Thameside West

Energy and Sustainability Statement

Addendum

May 2020

Figure 2—2 Measures to reduce overheating risk reviewed and the impact on dwelling modelling results

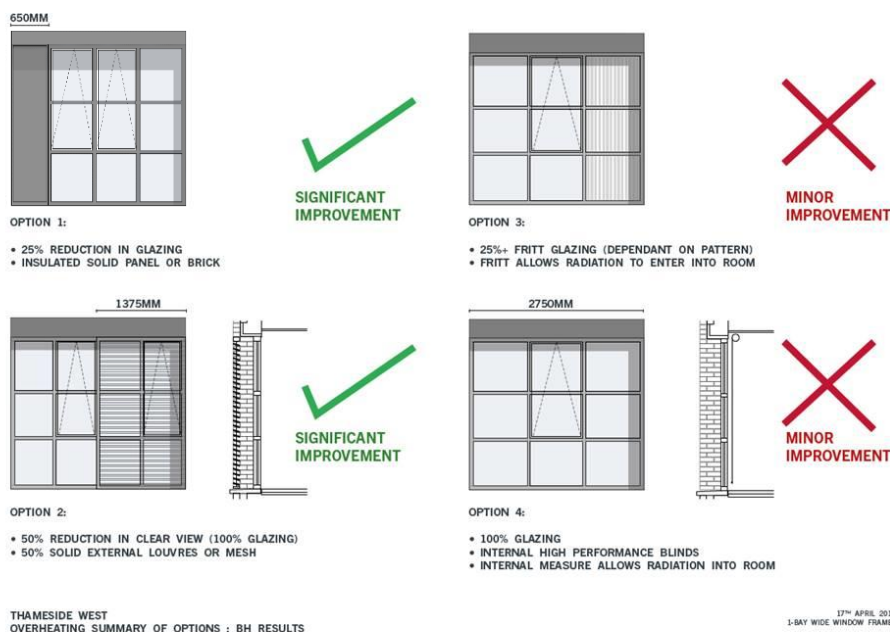
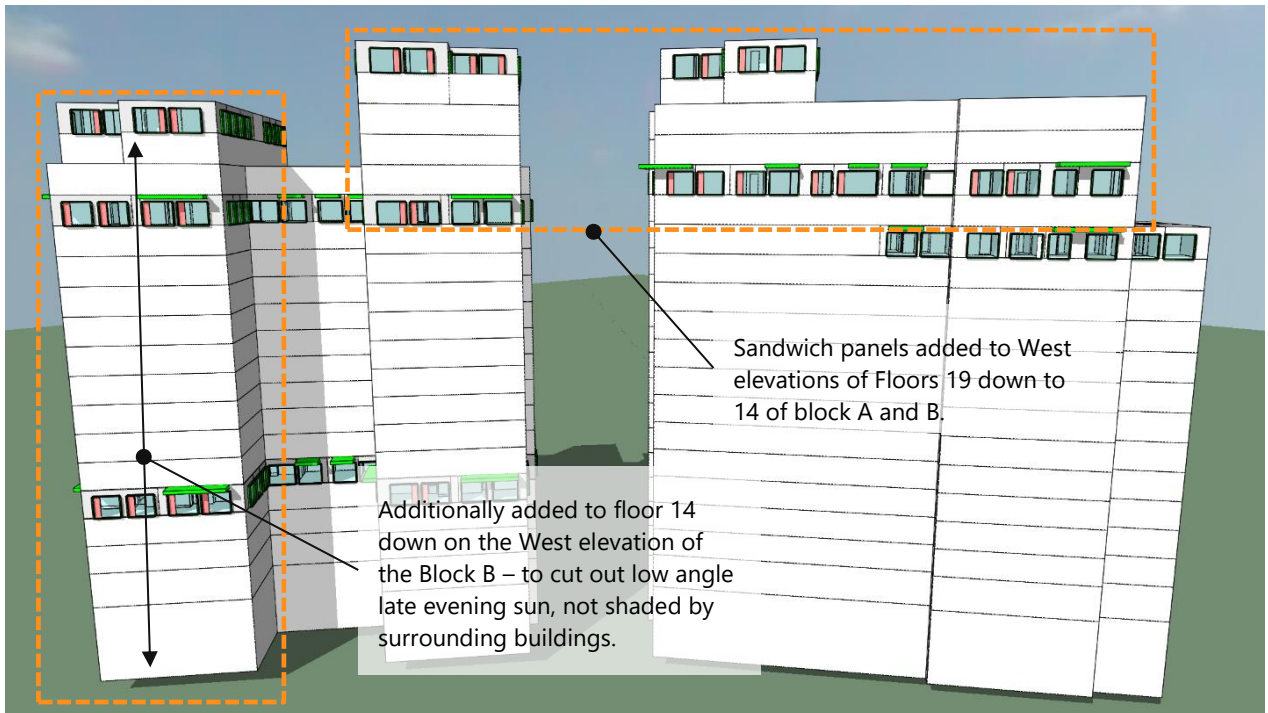
The applicant has reviewed the GLA's proposal and has reviewed a series of options to the windows that receive the highest solar gains. The options reviewed are outlined in Figure 2—2 and they consist of:

- Across all options: Reveal depth on all windows increased from 170mm to 315mm
- Option 1 – 25% reduction in vision glazing with the introduction of a 650mm wide aluminium sandwich panel
- Option 2 – an 1375mm wide external louvered or mesh shade across 50% of the window area with a 50% free area
- Option 3 – Fritting to be added to 25% of the glazing area
- Option 4 – improved solar control blind specification and fit out

Options 3 and 4 have been ruled out as they show limited impact on the overall risk profile beyond that outlined in the original design. Therefore option 1 and 2 have been explored further. These options show reduce risked risk to all units these measures are applied to and show very similar outcomes to each other.

As a result Option 1, change of a glazing pane to an aluminium sandwich panel, is proposed to be taken forward. This has been chosen over option 2, additional of an external shade, as option 1 will have increased capital cost and additional maintenance requirements for the occupants. Additionally option 1 does not impact the aesthetic of the glazing across different levels of the building, providing the same fenestration design in areas of low daylight and overheating risk.

Figure 2—3 Sandwich panel addition strategy modelling IES

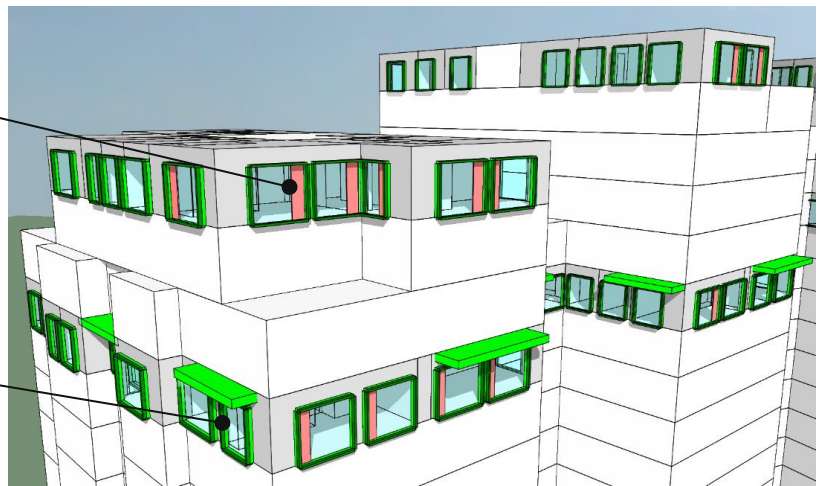
The applicant has reviewed further passive measures, which is welcomed. They have considered deepening reveal depths on all windows from 170mm to 315mm, which they propose to adopt. They have assessed the impact of adding fritting to a proportion of the glazed area, and also of using an improved solar control blind specification, but neither of these provided significant improvements and so they were ruled out. Two further options were assessed in more detail; 1) a 25% reduction in vision glazed area with the introduction of a 650mm wide aluminium sandwich panel and 2) an external louvred mesh across 50% of window area. Both options were tested against CIBSE TM59 for a representative set of upper floors, and additional modelling was undertaken on lower floor units to understand the overheating risk lower in the build. The applicant has chosen to implement the 25% reduction in glazing, which will be preferable for capital and operational cost, and will maintain the same fenestration design across the building; this is proposed to the west elevations of floors 14-19 of Block A and part of block B, and also down to the ground (unshaded by surrounding buildings) part of block B.

External window reveal depth have been increased from 175mm to 315mm; reducing solar gain from both high and low angle sun throughout the day.

Sandwich panels added to West elevations of Floors 19 down to 14 of block A and B.

Additionally added to floor 14 down on the West elevation of the Block B – to cut out low angle late evening sun, not shaded by surrounding buildings.

Figure 2—4 Overheating risk of units for run 2 and run 3 1989-2020

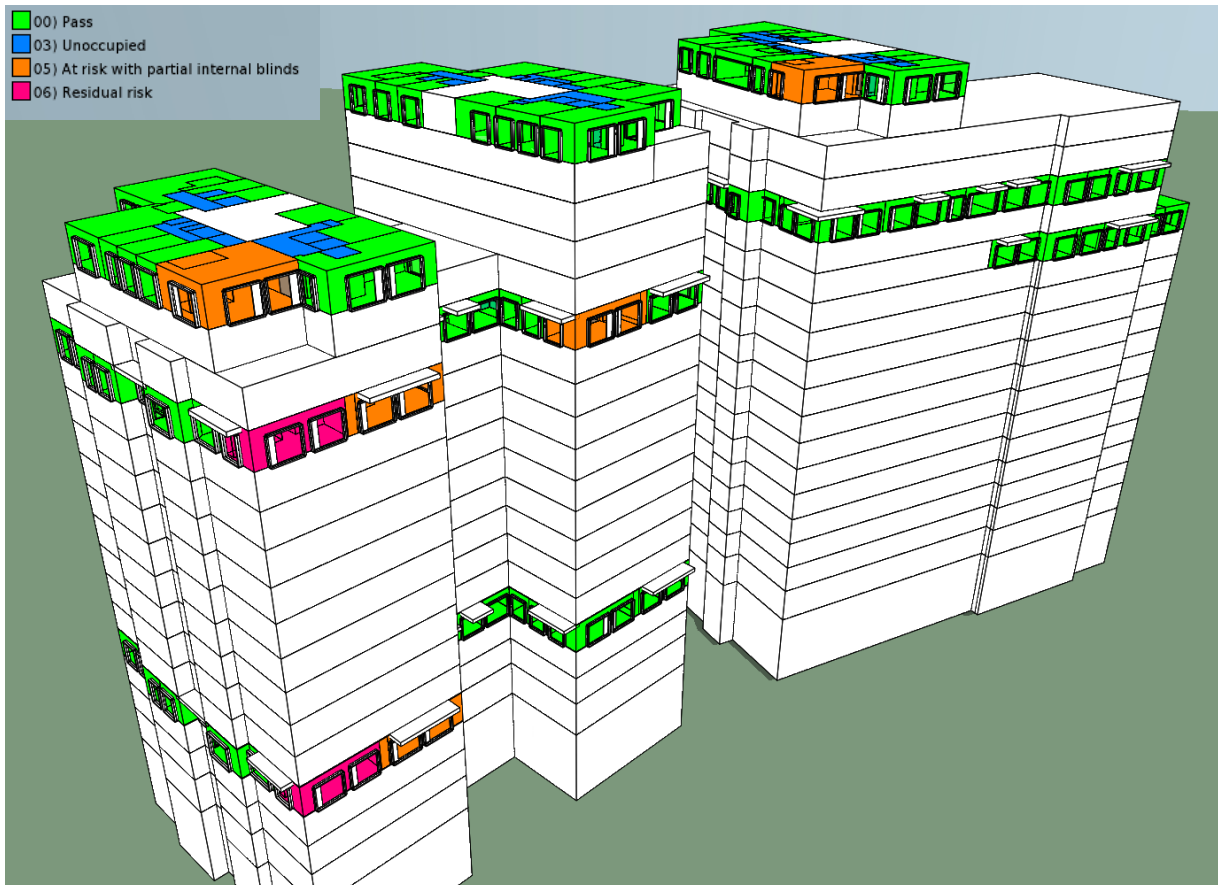
Figure 2—4 Shows the location of the spaces that show an overheating risk from Run 2 in Orange and those that show residual overheating risk from Run 3 in Pink future weather 1989 2020. The spaces that show a risk with internal blinds partially down are living room and kitchen spaces where low angle solar gains are penetrating between buildings and into the spaces. These spaces are generally overshadowed by the buildings around them throughout the year, therefore the use of movable internal blinds is proposed as the most reasonable measure to reduce overheating risk for these locations without negatively impacting on daylight significantly.

The four spaces that show a residual risk even with internal blinds fully down, as per run 3 and in pink, will need to be reviewed further and this is proposed to be undertaken through a condition for the detailed Phase 1 application.

Figure 2—5 Typical window typology on the West facade

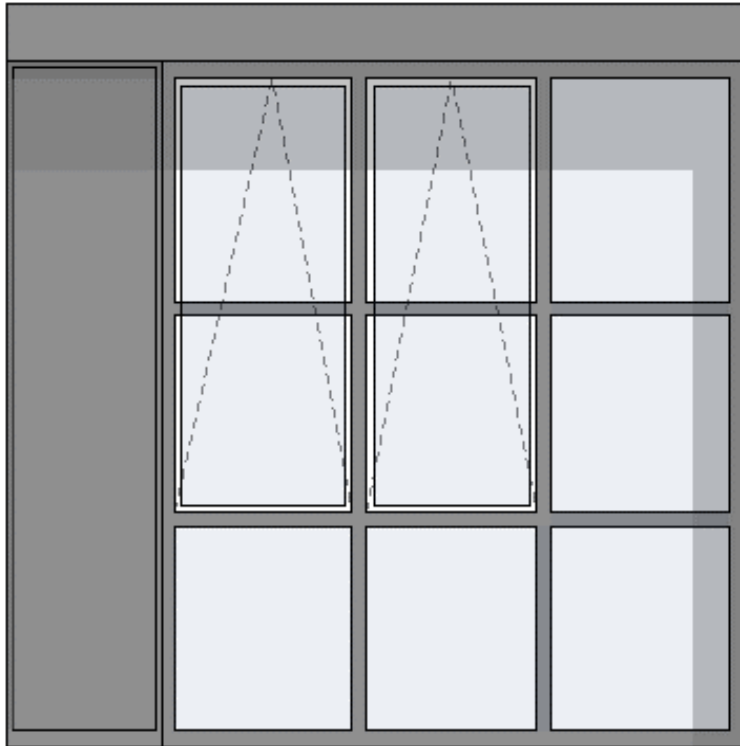
The applicant has considered how the use of internal blinds could impact on venation rates. As a result the glazing and opening pane types have been designed to maximise flexibility for occupants to install and operate different blind types, whilst limiting the impact on ventilation. Figure 2—5 outlines a typical window typology for phase 1 of the scheme. It shows a Crittall style window split into four equal full height panes with different conditions.

The window type are built up of either a solid element which could either be glass or aluminium sandwich panel, out the outer panes. The inner two panes will have an openable top hung window. These will be positioned in the middle to avoid any reduction in air flow from the external reveals, allowing for free movement of air. Additionally the fixed pane design allows for 50% of the window to have an internal blind drawn from both sides, whilst still allowing completely free movement of air through the openable panes. Blinds will be fit by the occupant, rather than the developer, and this window design would lend itself to a side drawn blind or traditional curtain.

Figure 2—11 Corridors and risers as modelled in IES VE based on smoke venting strategy

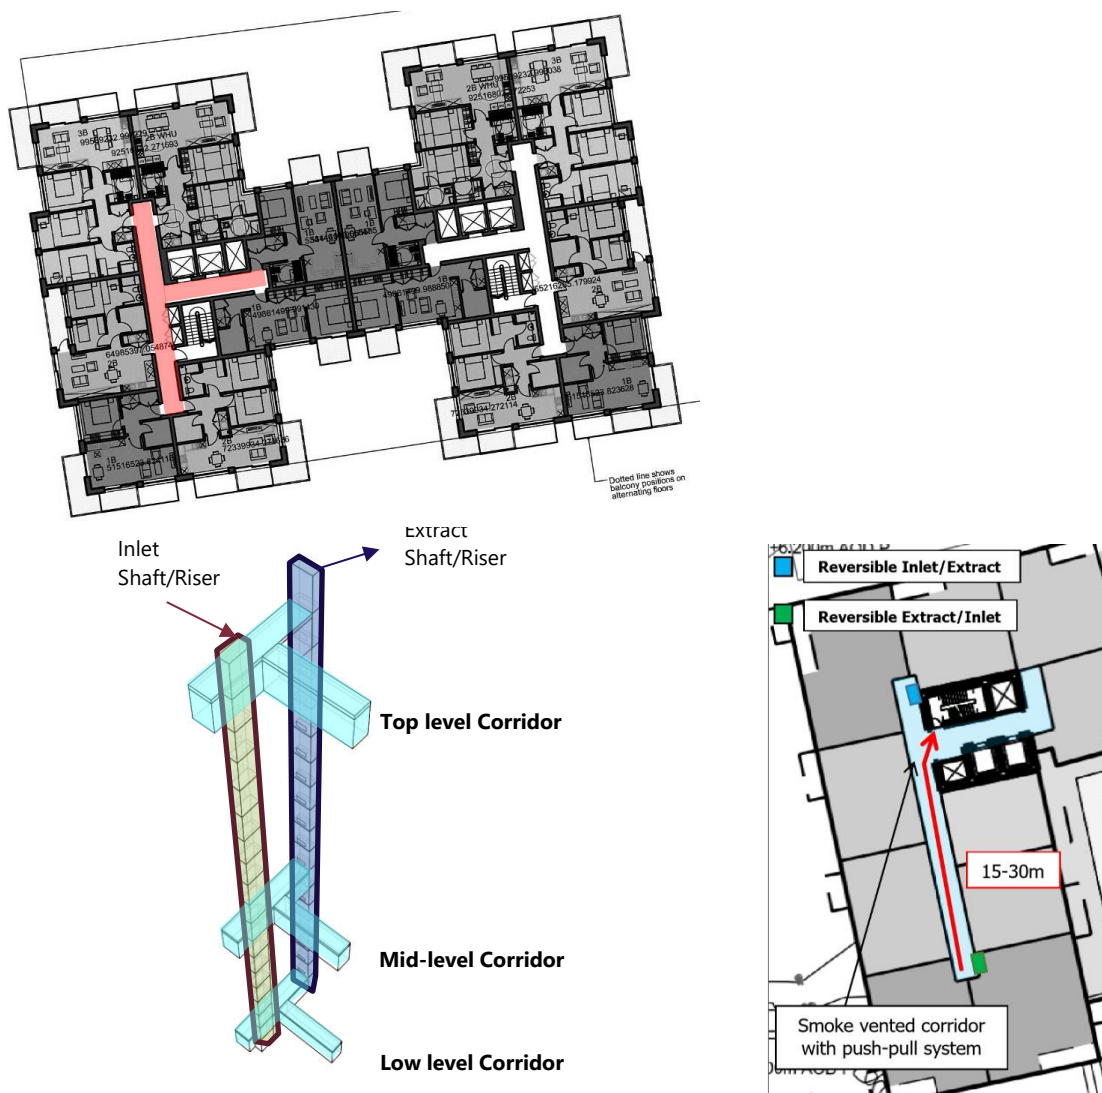
The section details the assessment methodology and overheating results based on thermal model inputs and the ventilation strategy assumed in the corridor.

As outlined in Figure 2—11 a typical corridor at the top middle and bottom of the Block B has been modelled. The fire strategy requires that the corridor will have the sprinklers and a mechanically assisted “push/pull” smoke control system. In this system a smoke shaft is provided at each end of the corridor with reversible fans. One shaft provides an inlet and the other shaft extract depending on the location of the fire, and is designed to flush smoke away from the staircase. It is proposed that this systems will provide back ground ventilation for the corridor, very typical in residential developments.

Figure 2—12 Annual Operative temperature profile

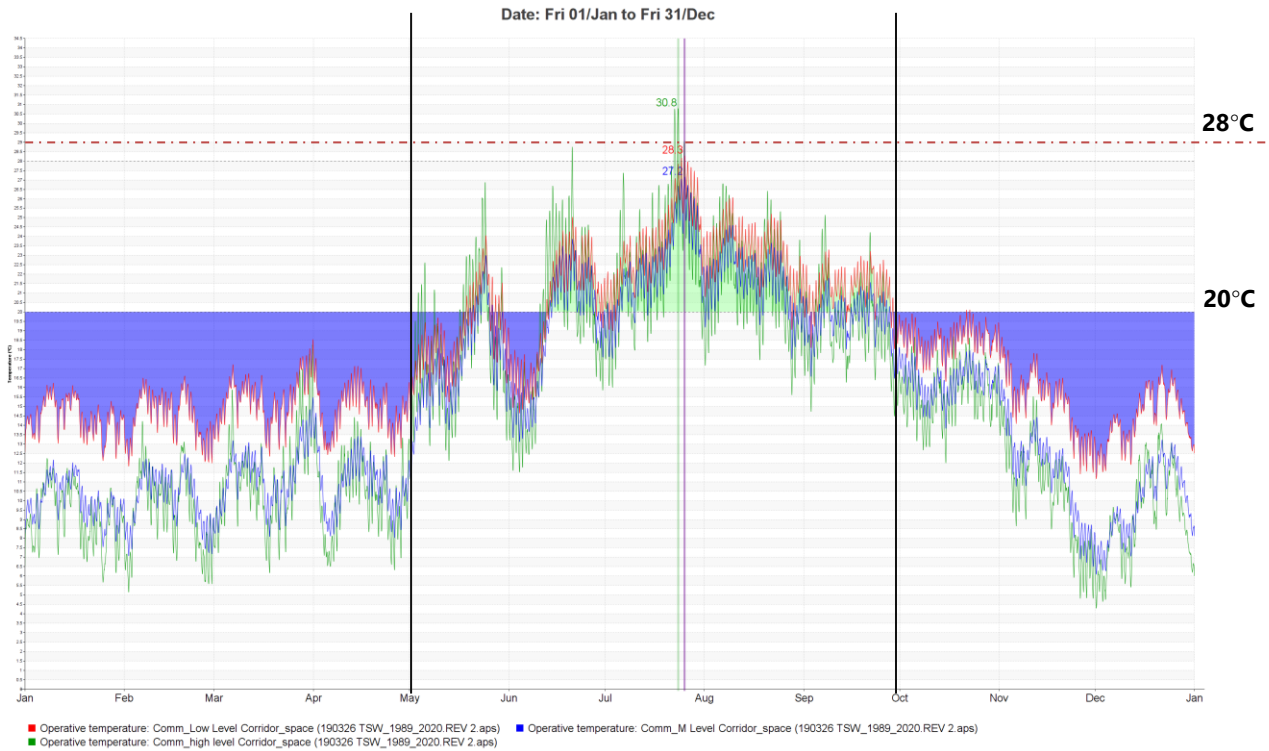
The results for communal corridors are shown in Table 2—6 and Figure 2—12 demonstrate that the recommendation of CIBSE TM59 for corridors is achieved. It is therefore concluded that although elevated temperatures are predicted to occur on hottest day (25/July), the percentage of total hours across the year will not exceed the 3% and the conditions within the corridor would not be expected to cause thermal discomfort to people passing through it.

Figure 2—13 Review of glass manufactures g-value vs VLT

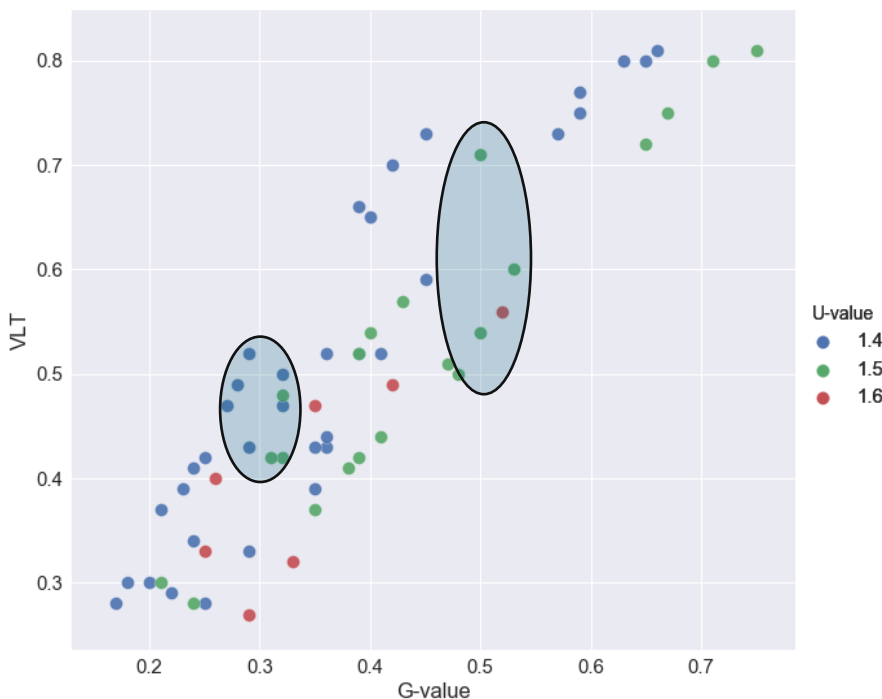
21. The g-value of 0.3 is low and the applicant should confirm the anticipated light transmission value, which will impact on daylighting performance.

A G-value of 0.3 is only applied to facades that receive higher solar gains. A review of a typical glass manufacture window types has been undertaken.

Figure 2—13 outlines the VLT (Visual Light Transmittance) range of glazing types based around a G-value of 0.3 (± 0.03). This shows that the VLT typically varies from 40% to 53%. Therefore the average VLT for a glazing speciation of 0.3 g-value would be 47%-50%. Variation between these numbers is based upon differing pane thickness, tints and reflective properties of the final glass specification.

The figure also shows that Where daylight is more challenging, for floors 2-13 that are overshadowed by surrounding buildings, a G-value of 0.5 is specified. This would expect to have a VLT in the range of 50% to 70%.

Figure 2—14 Detailed plant room layout and DHN connection routing for Phase 1

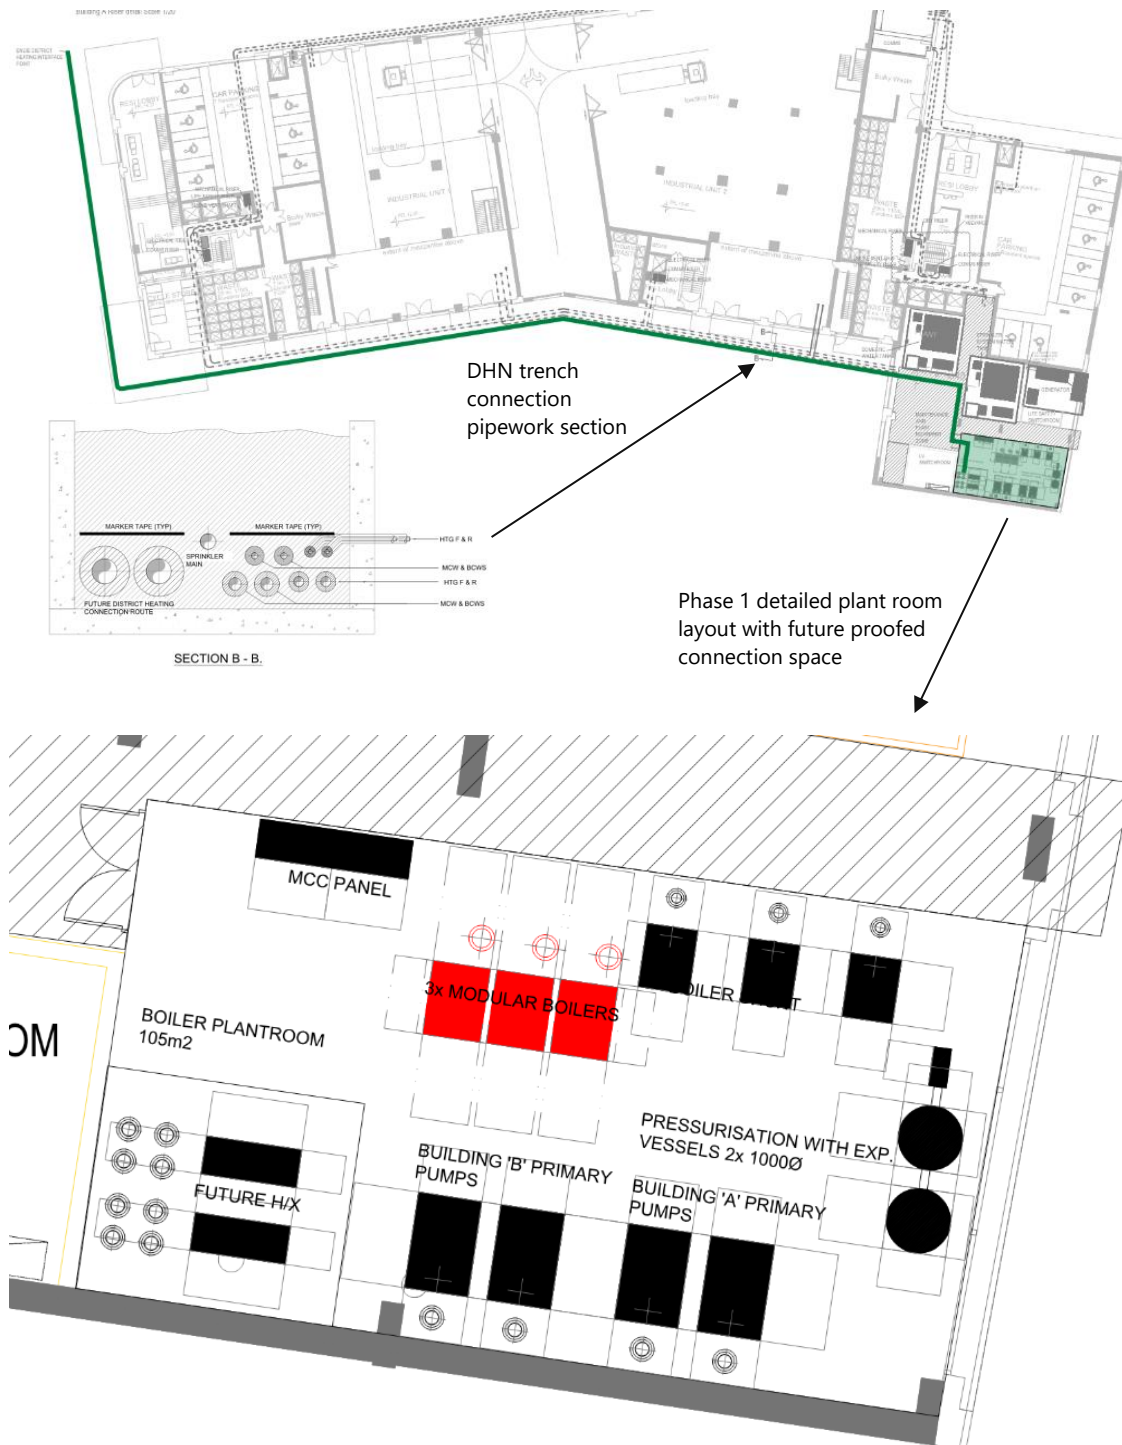
28. The applicant should provide a commitment to ensure that the development is designed to allow future connection to a district heating network. Drawings demonstrating how the site is to be future-proofed for a connection to a district heating network should be provided; these should include space provision for heat exchangers in the plant room, isolation valves, safe-guarded pipe route to the site boundary etc. Plant room layouts should be provided for the Phase 1 and 2/3 boiler rooms and show space for these features.

The development has been futureproofed in order to facilitate connection to a district heating network. The drawings below indicate the space provision for plant within phase 1 plant room, including plate heat exchangers as well as a safe guarded pipe route to the site boundary. Both domestic and non-domestic buildings shall be connected to the network. Phase 2 and 3 are currently in the outline design stages so no detailed layouts are available, however an indicative layout is provide in section 8.7.3 of the original report.

Figure 2—15 solar insolation displayed on Phase 1, 2 and 3, showing that different building heights and contexts affect the potential for solar energy harvesting

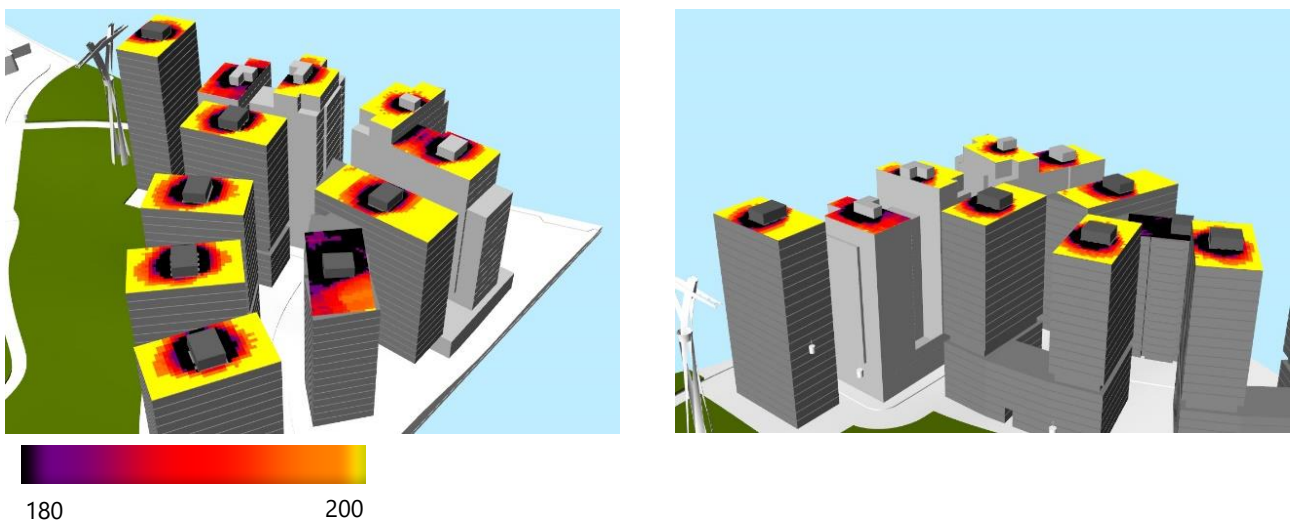
37. 25kWp of PV is being proposed for Phase 1, and 197kWp is proposed for the Phases 2-12 as included in the outline application. The applicant should confirm the proposed net PV areas. It appears that there might be additional space available for PV. A detailed roof layout should be provided demonstrating that the roof's potential for a PV installation has been maximised; they should outline the solar insolation and any other constraints. The applicant is required to maximise the on-site savings from renewable energy technologies, regardless of the London Plan targets having been met, and therefore the PV proposals should be reviewed.

As requested, we have outlined the predicted solar insolation for Phase 1, 2 and 3. Varying heights and contexts of buildings differentiates the insolation for each roof, have led to the conclusion that some areas would not be appropriate for solar energy harvesting (see Figure 2—15). We have maximised the potential where we think appropriate.
